SERVICE BULLETIN

N° 139-722

ATA 62 – MAIN ROTOR HEAD ASSY UPGRADE

This Service Bulletin provides the necessary instruction to perform the upgrade from the main rotor head assy P/N 3G6220A00132 to the main rotor head assy P/N 3G6220A00134.

Figure 1

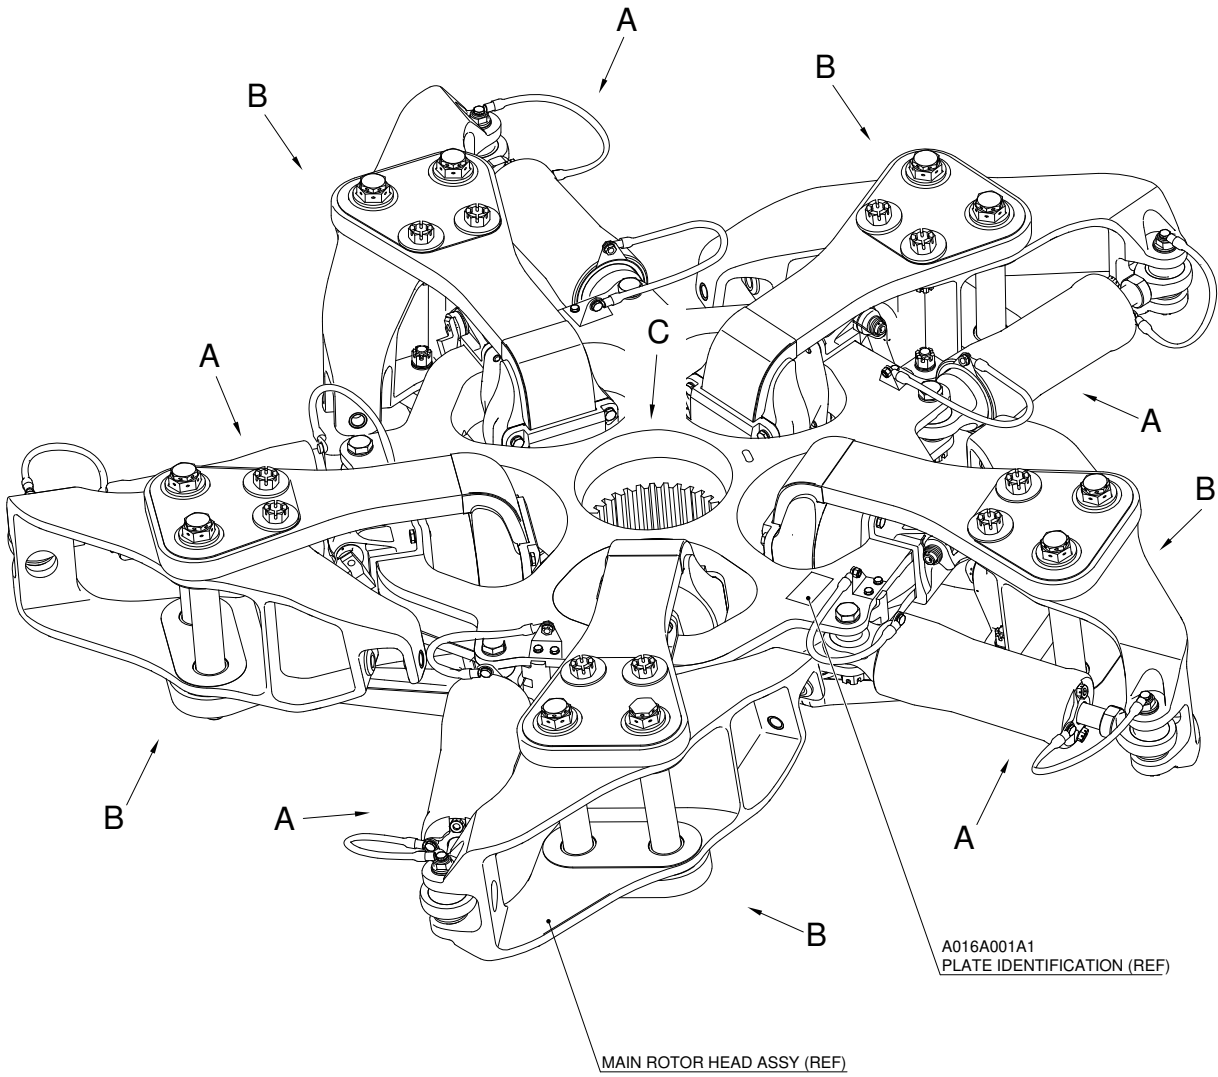
7. With reference to Figure 1, remark the main rotor head assy P/N 3G6220A00132 with P/N 3G6220A00134 and add "/1" near the S/N with an applicable vibropen, or equivalent, on the plate identification P/N A016A001A1.
8. Record for compliance with this Service Bulletin on the item logcard.
9. Send the attached compliance form to the following mail box:

Figure 2

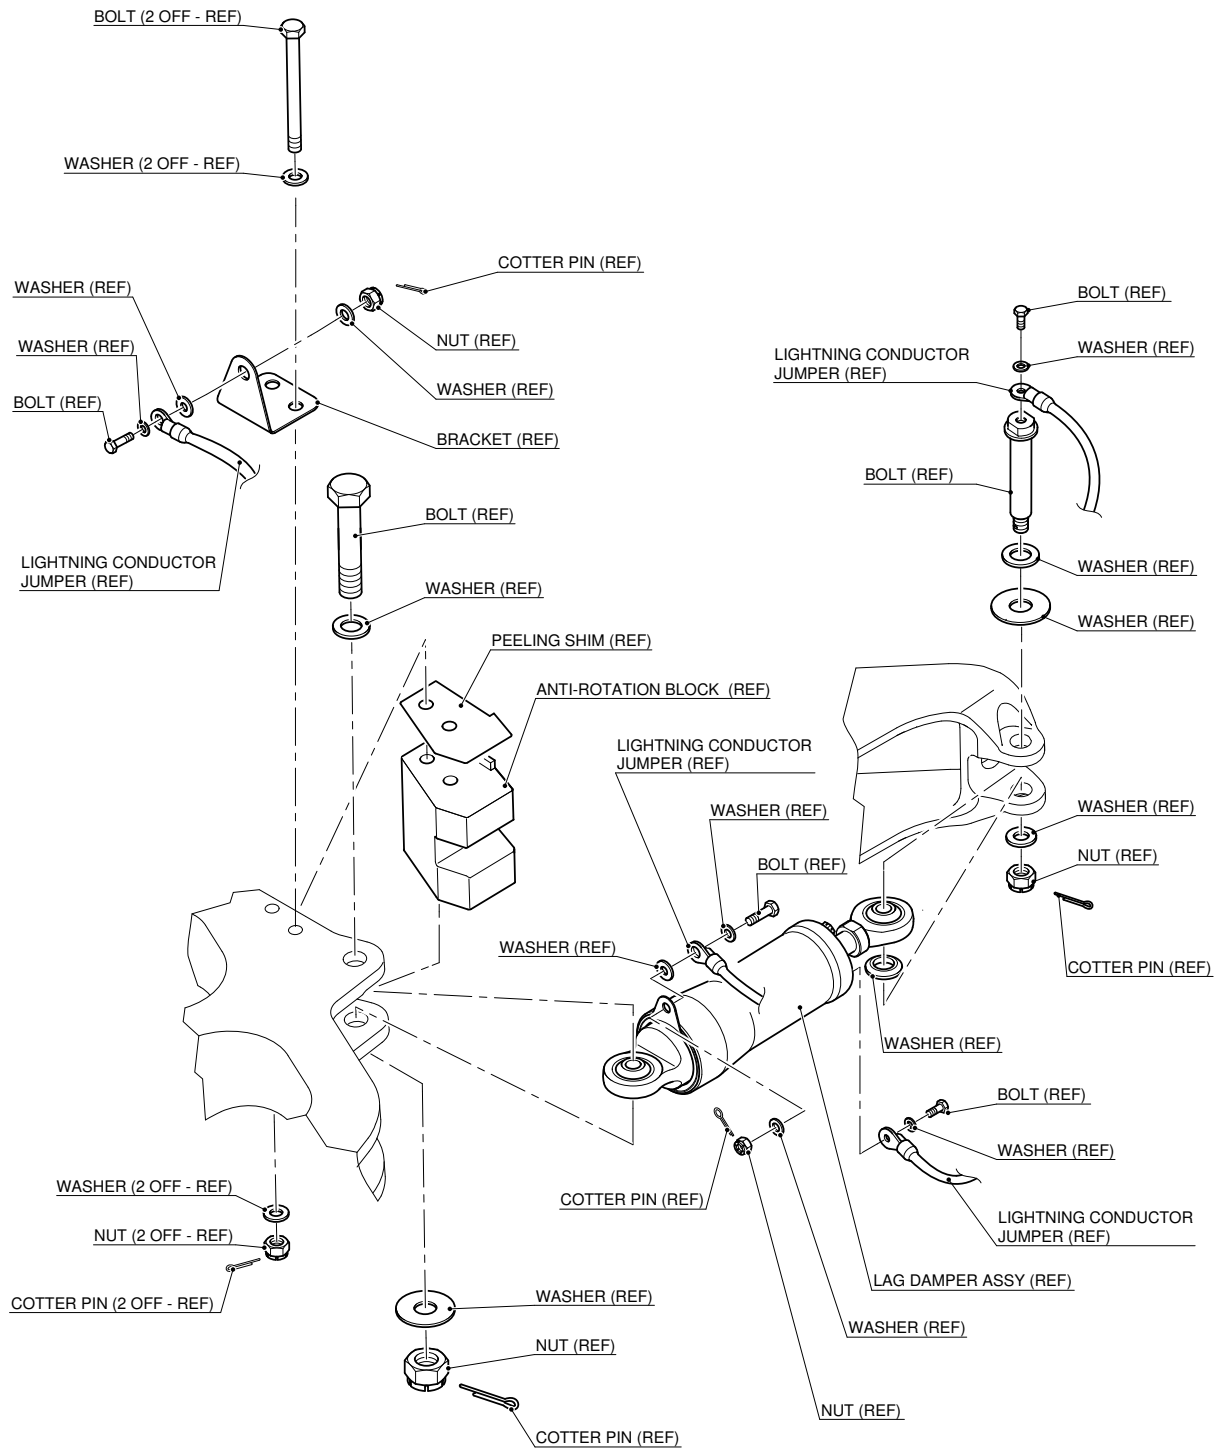
1. In accordance with applicable steps of AMP DM 39-A-62-22-00-00A-530A-B and with reference to Figures 1 thru 3, remove and discard the electrical bonding contacts P/N 3G6220A06631 or P/N 3G6220A06632.
2. In accordance with applicable steps of AMP DM 39-A-62-22-00-00A-530A-B and with reference to Figures 1 thru 3, remove and discard twenty flanged bushings P/N 3G6220A03251.
3. In accordance with applicable steps of AMP DM 39-A-62-22-00-00A-530A-B and with reference to Figures 1 thru 4, remove and discard the M.R. scissor attachment flange assy P/N 3G6220A00632.
4. In accordance with applicable steps of AMP DM 39-A-62-22-00-00A-710A-B and with reference to Figures 1 thru 4, install the M.R. scissor attachment flange assy P/N 3G6220A00633.

5. In accordance with applicable steps of AMP DM 39-A-62-22-00-00A-710A-B and with reference to Figures 1 thru 3, install twenty flanged bushings P/N 3G6220A03252.
6. In accordance with applicable steps of AMP DM 39-A-62-22-00-00A-710A-B and with reference to Figures 1 thru 3, install the electrical bonding contact P/N 3G6220A06633.
